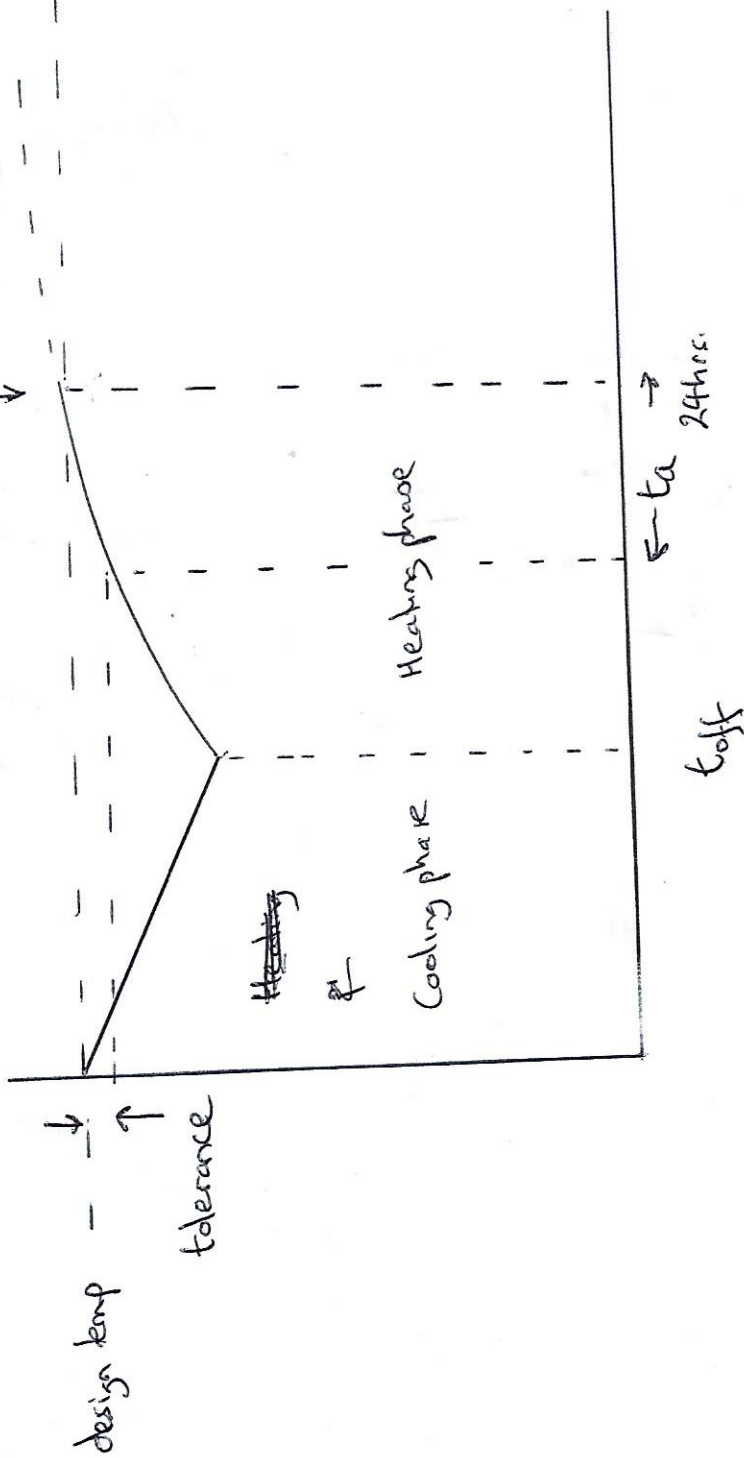
FT in setback case must be

set to the recovery curve reaches
the design temp 24hrs after the heating
was switched off
